OG # 23-044_HPA # 23-072

Project Address: 3615 Prospect Street NW

Project Description: replace roof, windows, siding, and fence; install guardrail at rear

CONCEPT SUBMISSION

PROPOSED
REAR WINDOW
& DOOR
REPLACEMENT
NOTES

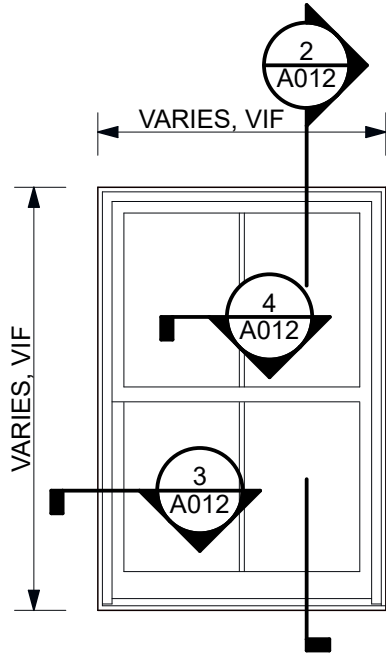
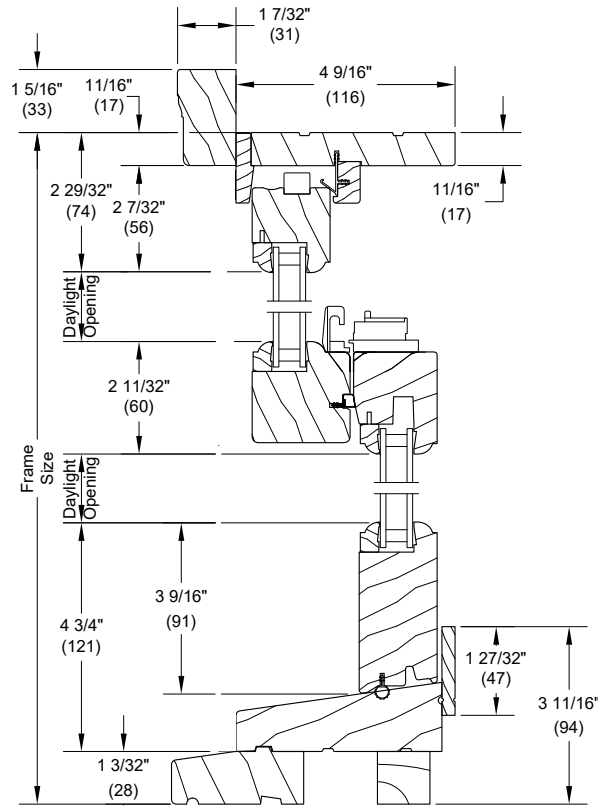
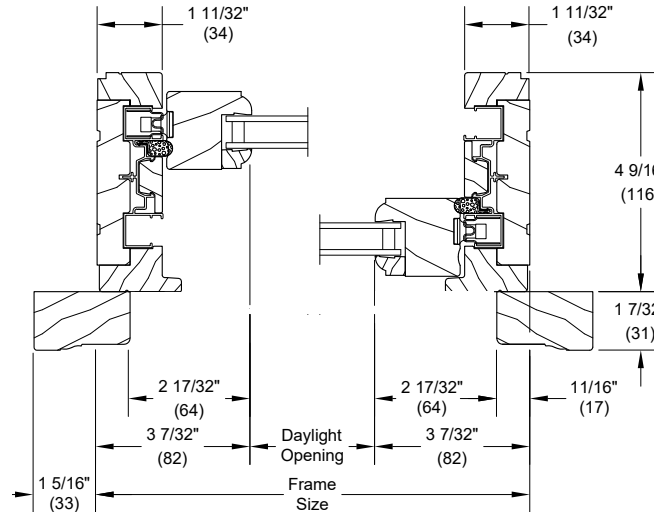
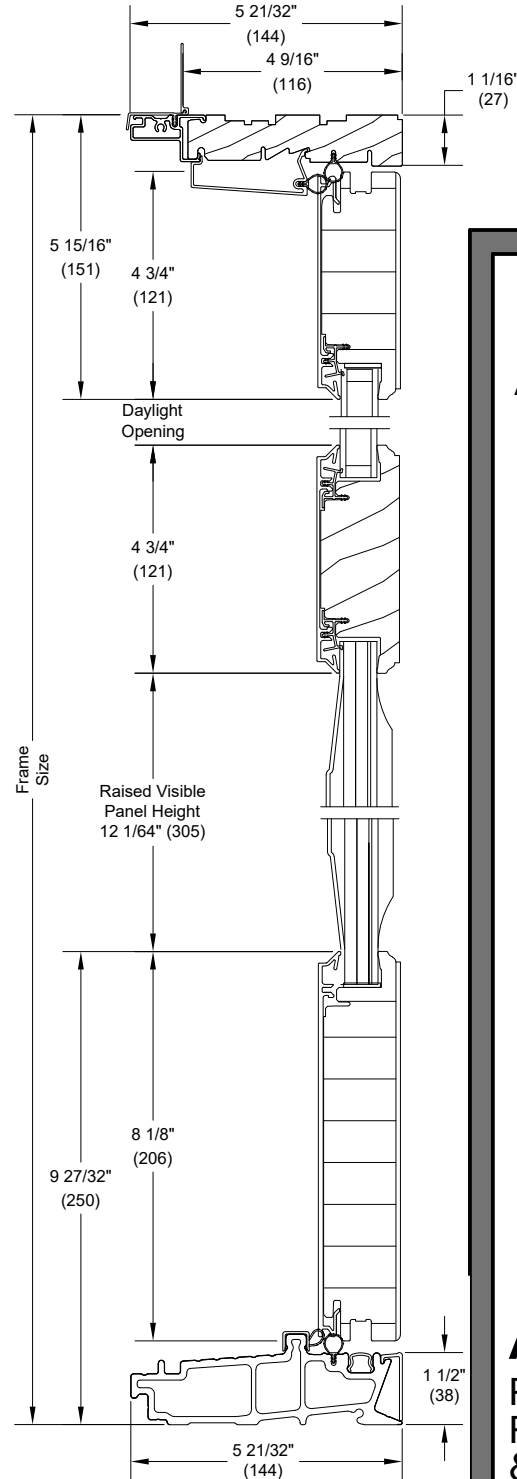
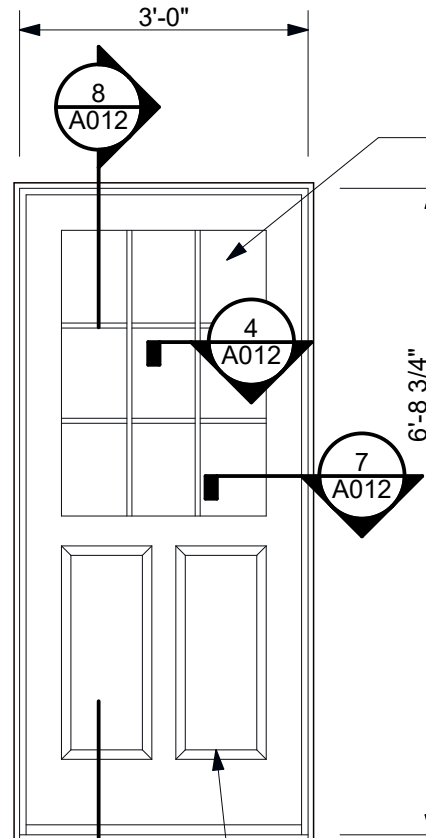
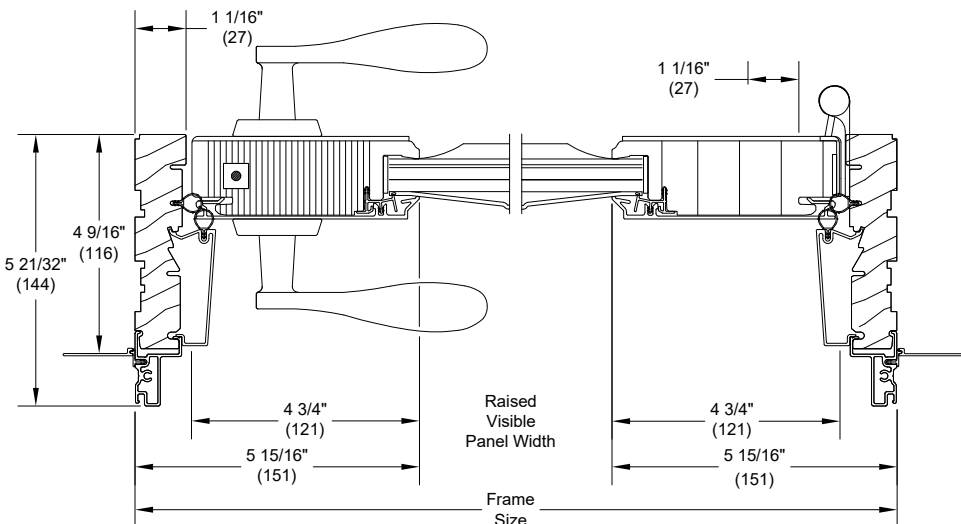
4. For the rear window details, please include existing and proposed detailed elevations and sections, showing accurate lite configurations and proportions. We need to understand that the trim would match that of the adjacent window. also include the wall in the section drawings. Also, only half-screens are approved, so please revise. **RESPONSE: NO SCREENS ARE PROPOSED.** I must also note that the Board has not support aluminum-clad windows in the past, and fiberglass has been approved only in special circumstances. We can still get their feedback from the Board on this item, but I wanted to let you know in advance. **RESPONSE: THE REAR WINDOWS HAVE BEEN CHANGED TO ALL WOOD, HOWEVER WE ARE STILL PROPOSING DOUBLE PANE. SEE SHEET A011 and A012.**

EXISTING AND PROPOSED DETAILS AT EXISTING ALLEY STUCCO

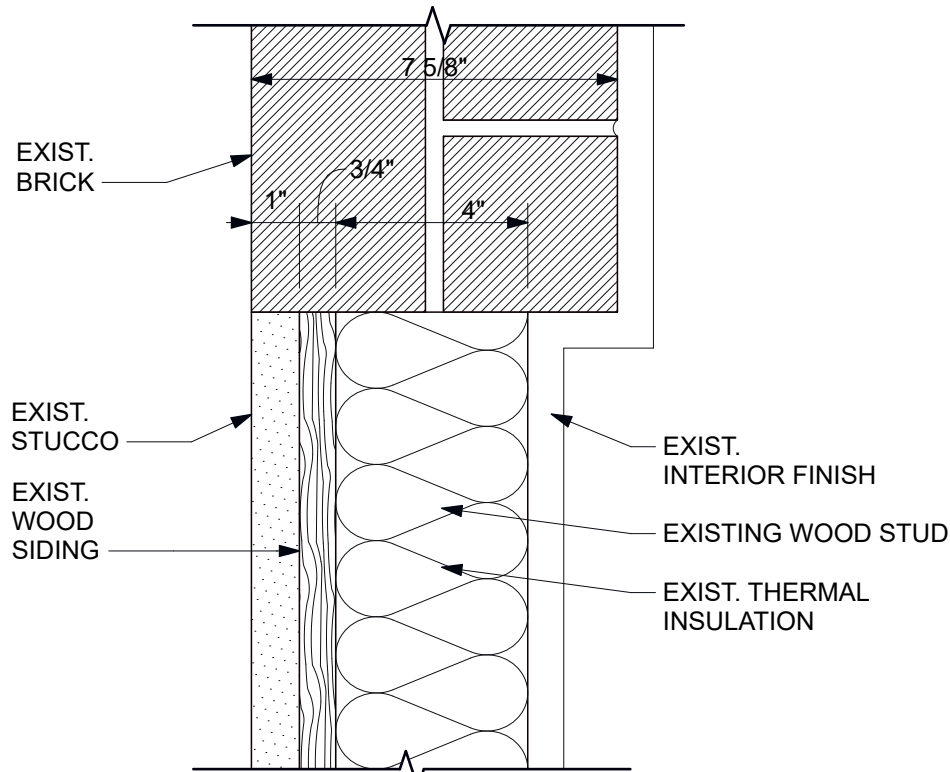
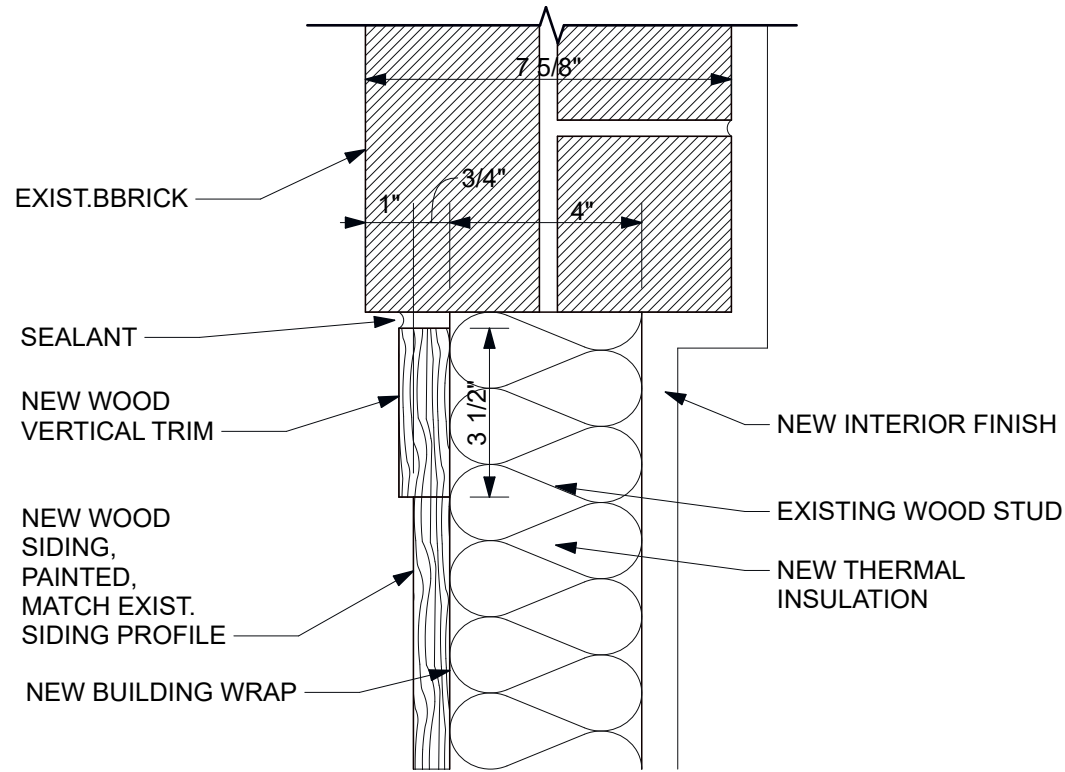
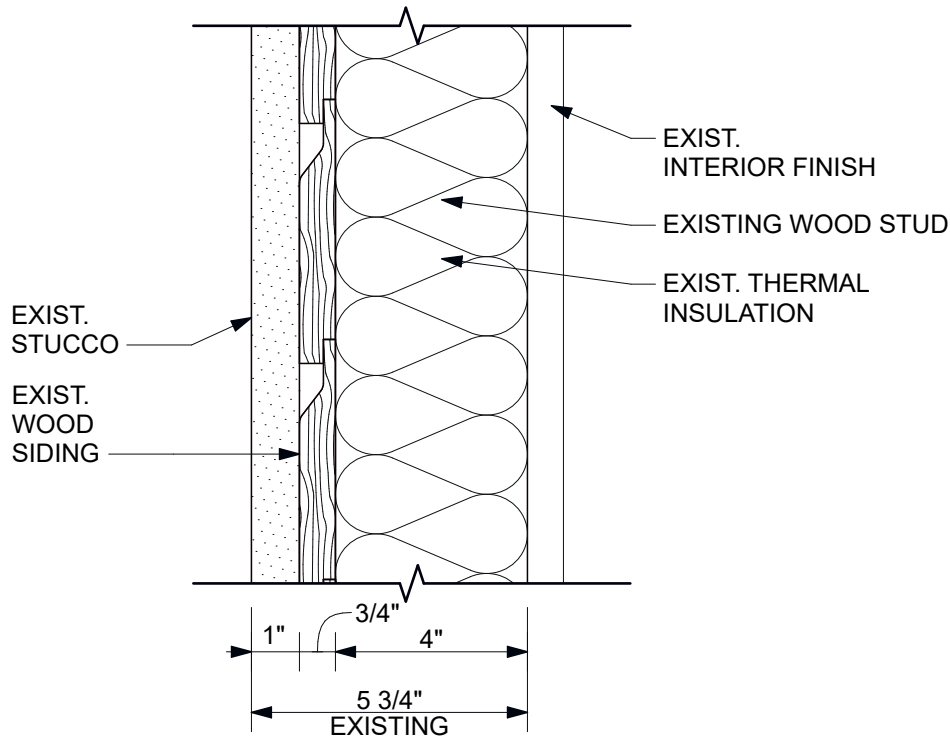
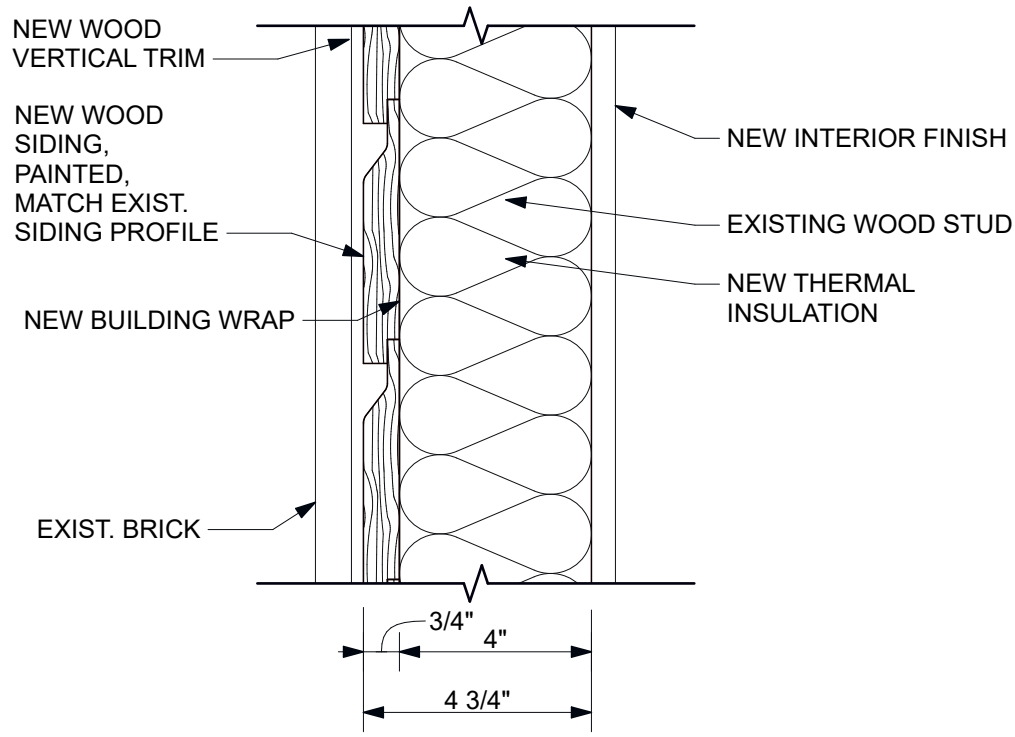
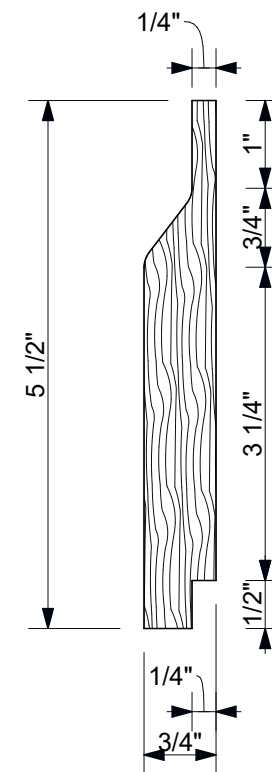
2. Please include details for stucco removal. The big question is, how will the brick on the front façade transition to the siding, since the stucco currently sits flush with the brick? We need to understand this condition. **RESPONSE: SEE UPDATED SECTIONS AND PLAN DETAILS ON SHEET A015. THE PLAN DETAILS SHOW THE WALL RELATIONSHIP TO THE EXISTING BRICK.**
